DEVELOPMENT CONSENT AUTHORITY
LITCHFIELD DIVISION

AGENDA ITEM: 1 **MEETING DATE:** 18/12/2026 **FILE:** PA2026/0327

APPLICATION PURPOSE:	Outbuilding (verandah and carport) addition to an existing dwelling-single with a reduced building setback to the side boundary
SUBJECT SITE:	Section 2920 Hundred of Strangways (247 Virginia Rd, Virginia NT)
ZONE:	RL (Rural Living)
SITE AREA:	2ha
APPLICANT	Mr Ilayaraja Inbasekaran
PERSONS ON WHOSE BEHALF THE APPLICATION IS MADE	N/A
LANDOWNER	Mr Ilayaraja Inbasekaran & Mrs Agila Nagarajan
ANY PERSON WITH AN AGREEMENT TO ACQUIRE AN INTEREST IN THE LAND	None

Figure 3: Setbacks of Proposed Structure

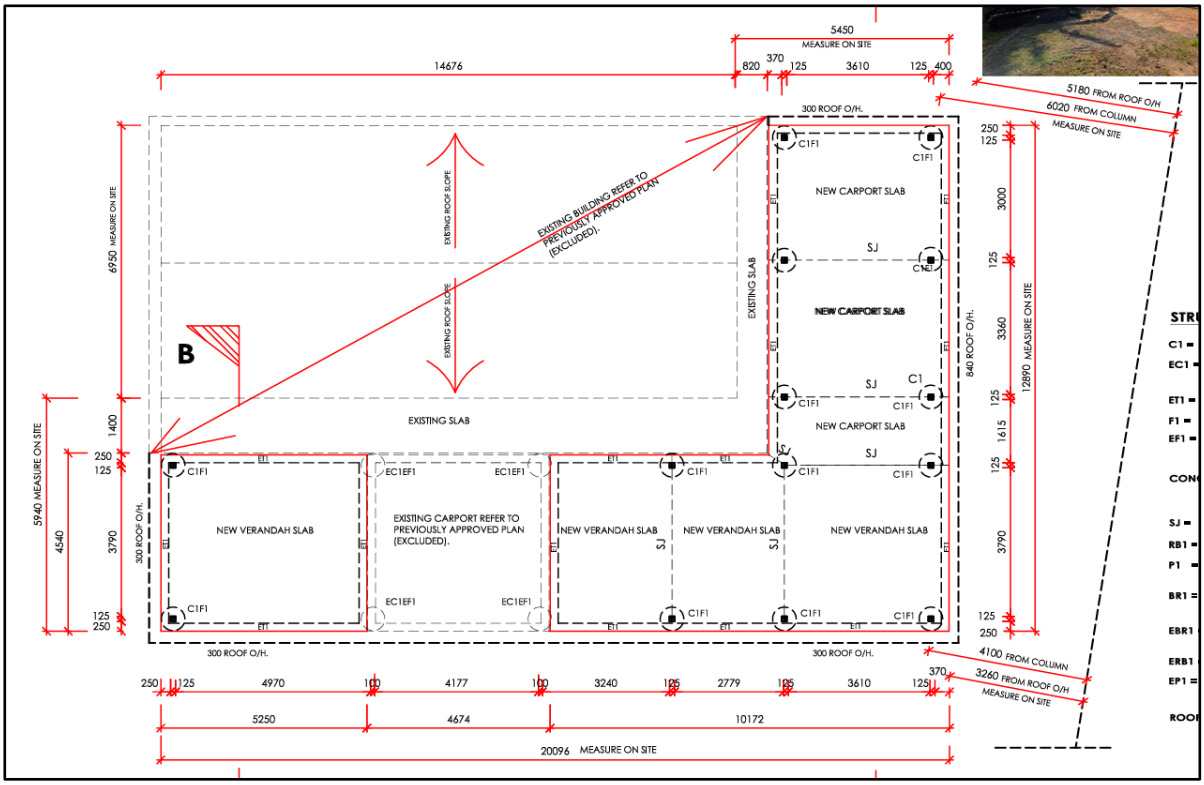
This proposal results in a setback to the side boundary of 4.1 metres at the location of the westernmost post to a height of approximately 3 metres, with the setback increasing to 6.02 metres at the eastern end (as shown below in Figure 3). It is an open single storey structure, forming a verandah and a carport to the existing dwelling single. Through conditions, amenity impacts on neighbouring properties can be minimised. This includes a condition precedent, requiring amended plans showing privacy screening to the southside of the new verandah. A standard condition will also require external lighting to be designed, baffled and located so as to prevent any adverse effect on adjoining land to the satisfaction of the consent authority. These conditions will minimise amenity impacts to the neighbouring property at 255 Virginia Road.

Floor Plan - Sheet 2 of 7, reproduced for reference.

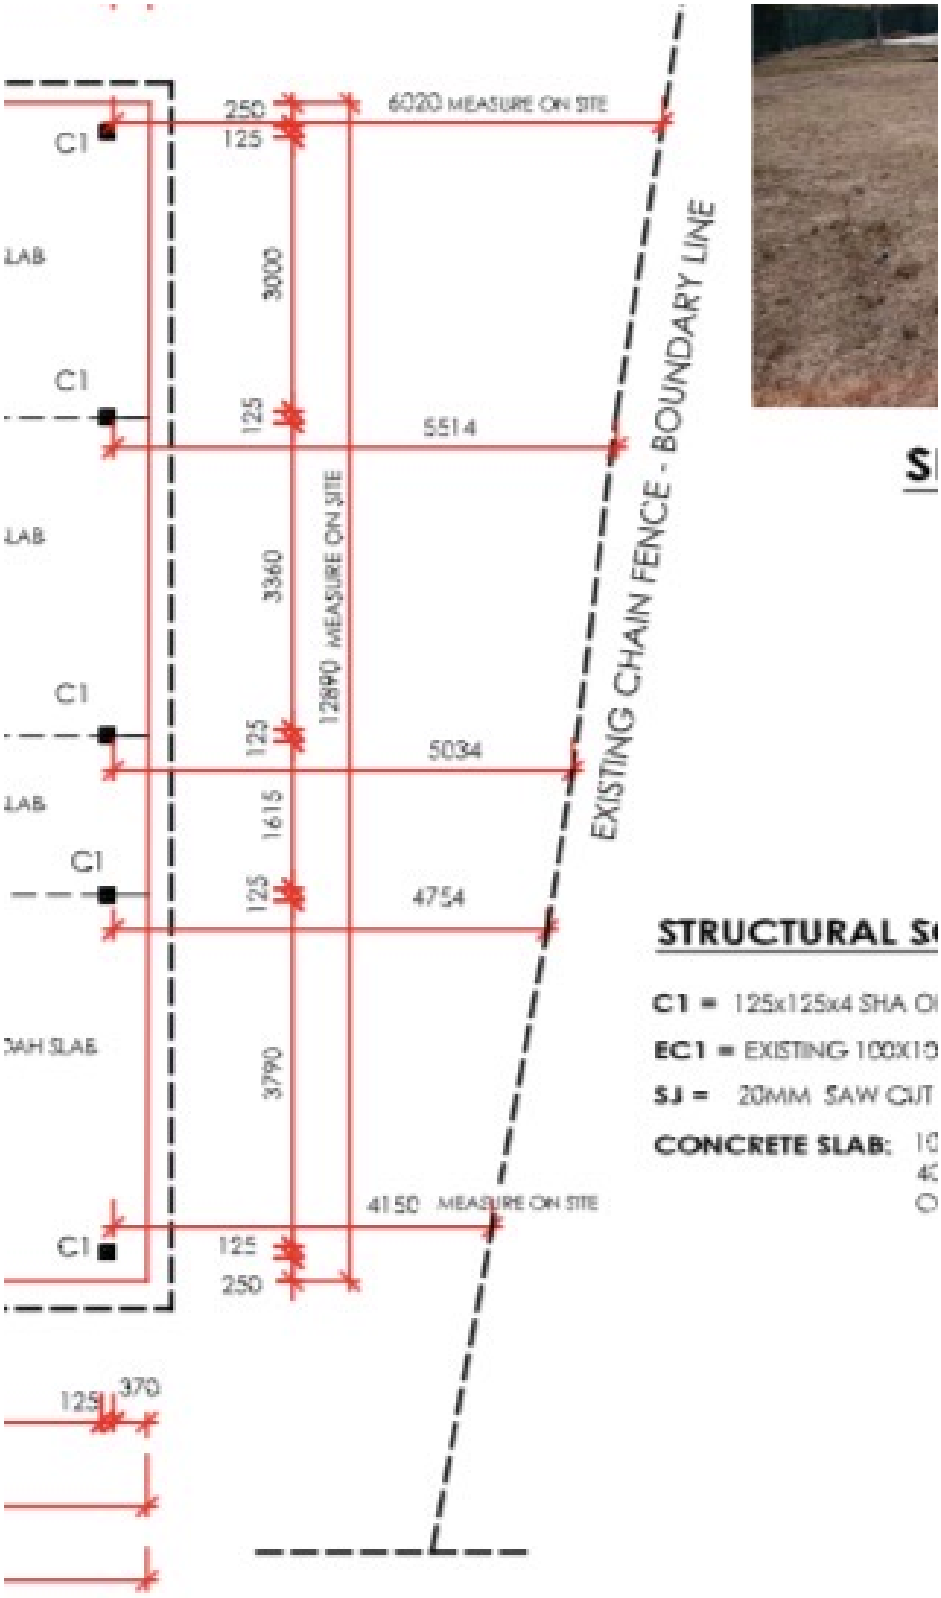
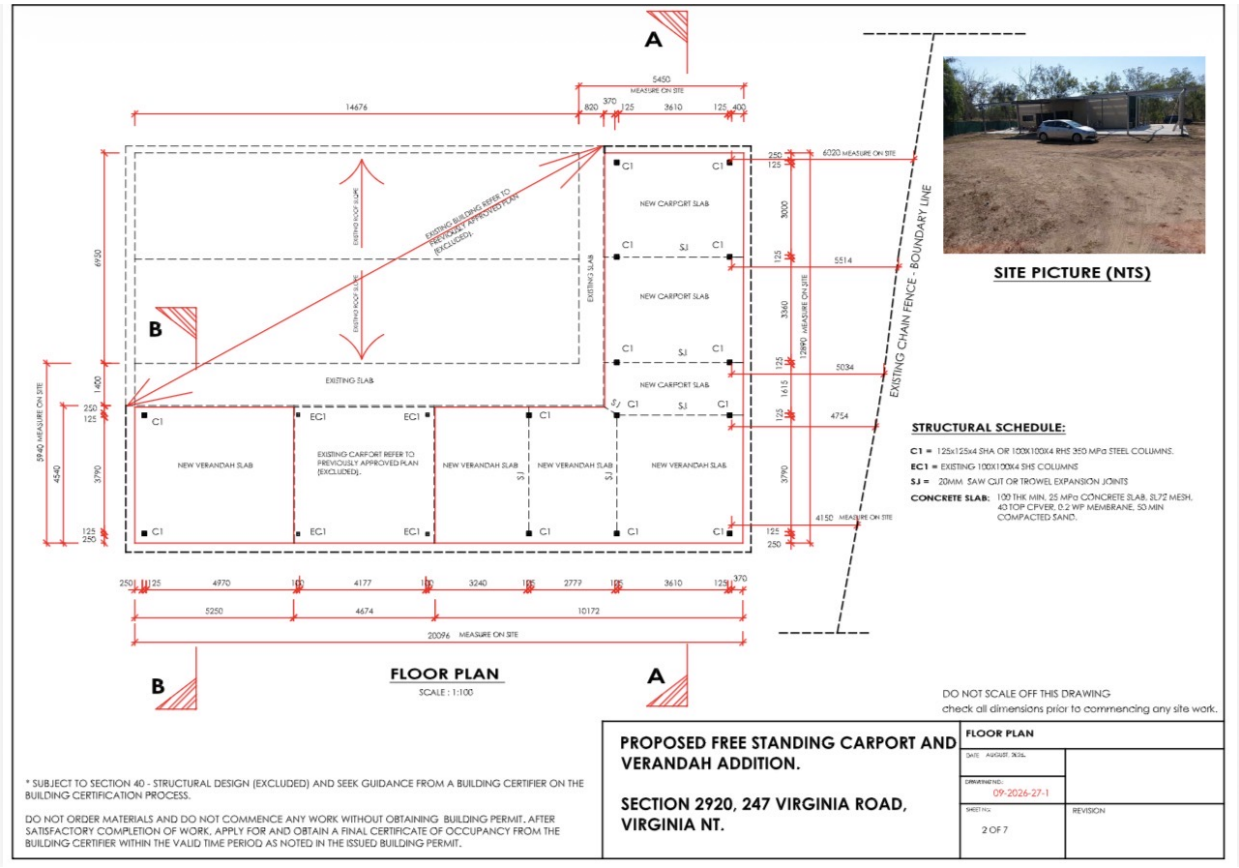
This additional information is provided to clarify the side-boundary measurements shown on the submitted floor plan. Of the five right-side measurements identified on the drawing, only two are below 5.0 metres.

C1 location / measurement	Distance	Clarification
Lower/right C1	**4,150 mm (4.150 m)**	This is the shortest site-measured distance shown at the lower/right C1 location. It is one of the two locations currently shown at less than 5.0 m.
Next right-side C1	**4,754 mm (4.754 m)**	This is the next site-measured distance shown along the right-hand side. It is the second and only other location shown at less than 5.0 m.
Other right-side measurements	**5.034 m** **5.514 m** **6.020 m**	These three measurements are already 5.0 m or greater.

If Development Assessment Services considers that relocating these two C1 columns to achieve a **minimum 5.0 metre setback** would assist in resolving the setback matter during assessment, I am willing to revise the proposal by relocating the two C1 columns currently shown at **4.150 m** and **4.754 m** so that each column is positioned at least **5.0 metres from the side boundary**. Any such alteration would be reflected in revised drawings and would remain subject to the required structural design and building certification. I respectfully request that DAS advise whether this adjustment would be acceptable or required as part of the assessment.

FLOOR PLAN

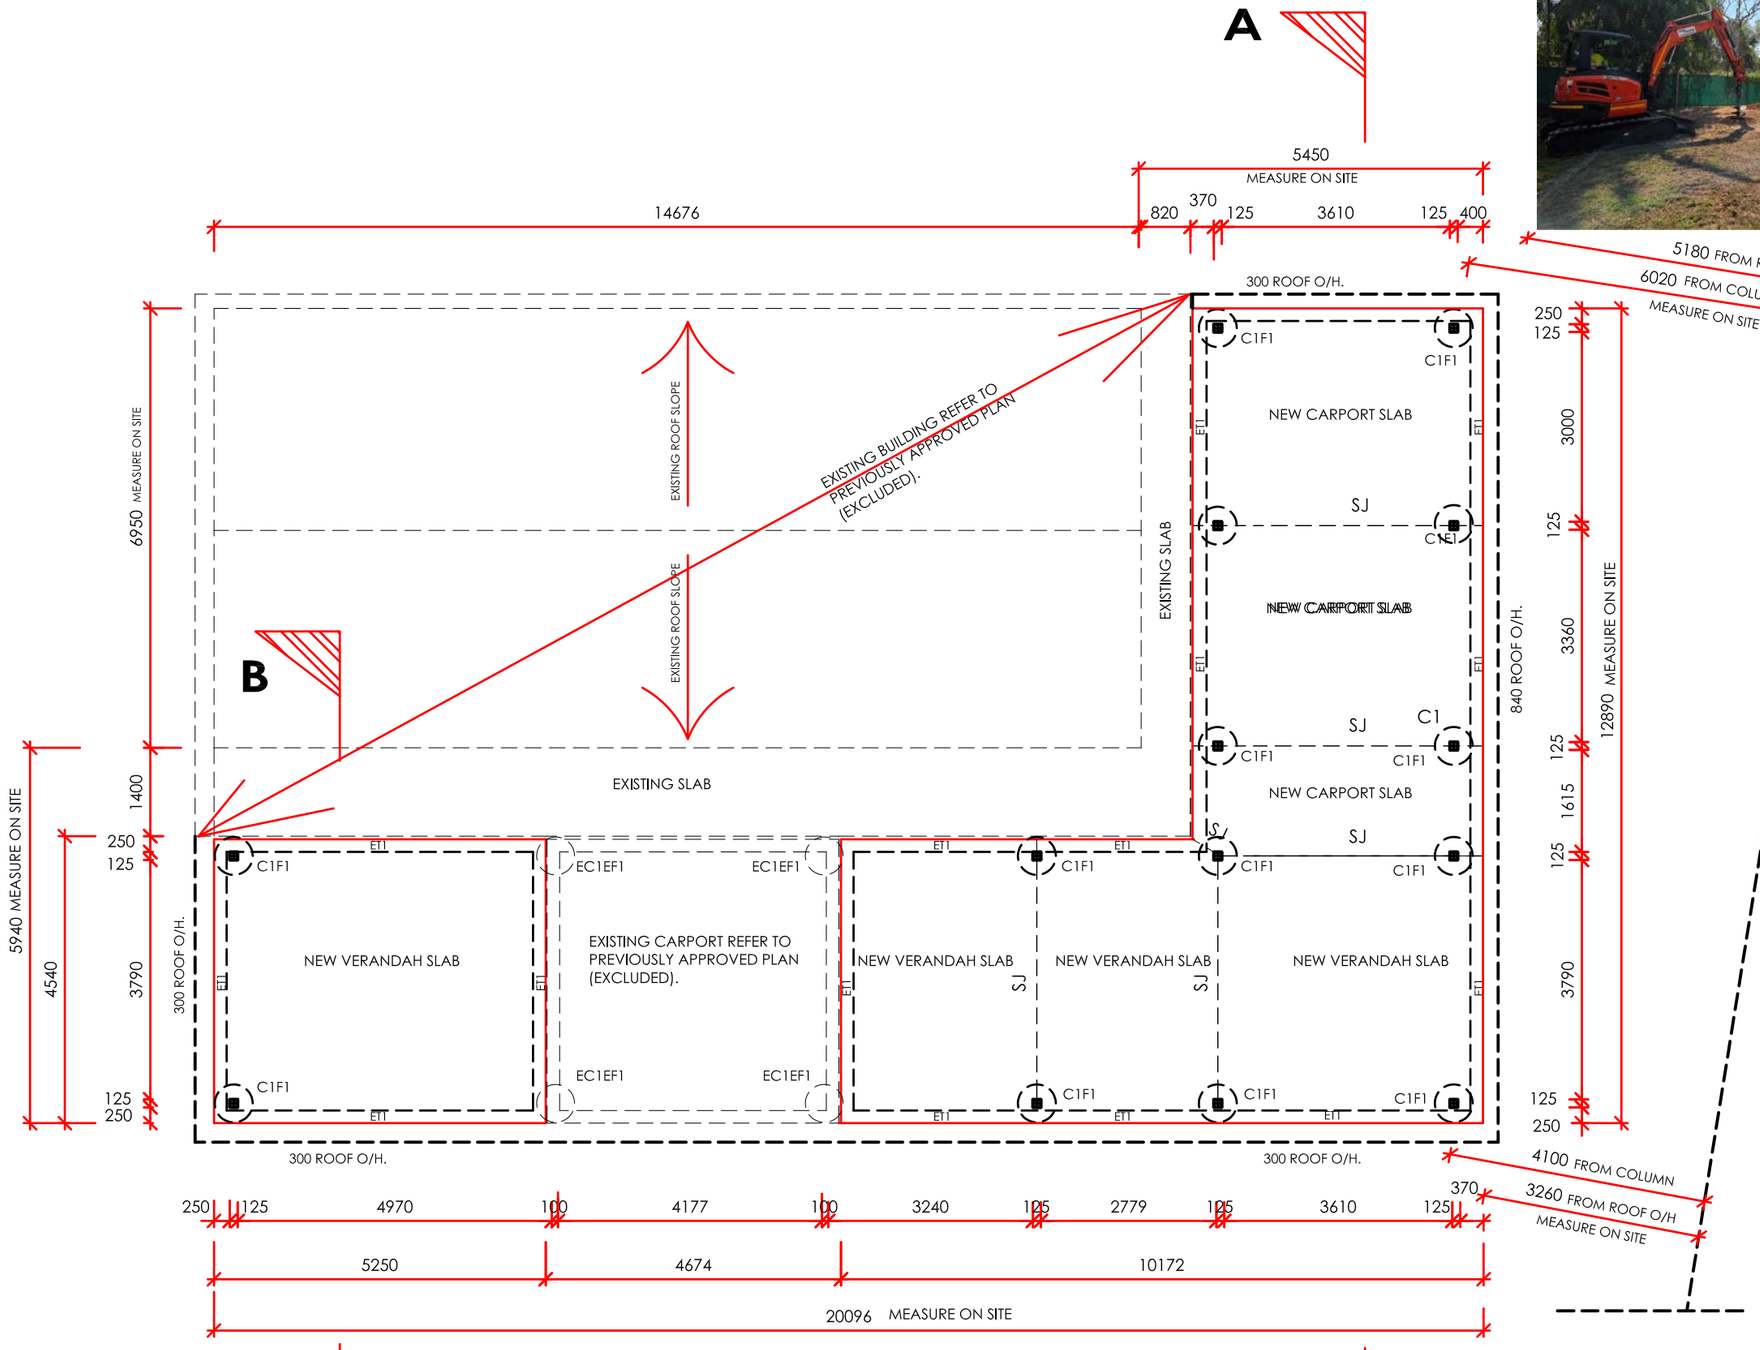
In response to Development Assessment Services, the revised drawings show the shortest/perpendicular setbacks to the relevant side boundary. At one end, the setback to the structural column/building line is 4,100 mm (4.10 m) and the setback from the side boundary to the roof eave is 3,260 mm (3.26 m). At the other end, the setback to the structural column/building line is 6,020 mm (6.02 m) and the setback from the side boundary to the roof eave is 5,180 mm (5.18 m). These dimensions clearly identify the extent of the structure and roof projection within the setback area.
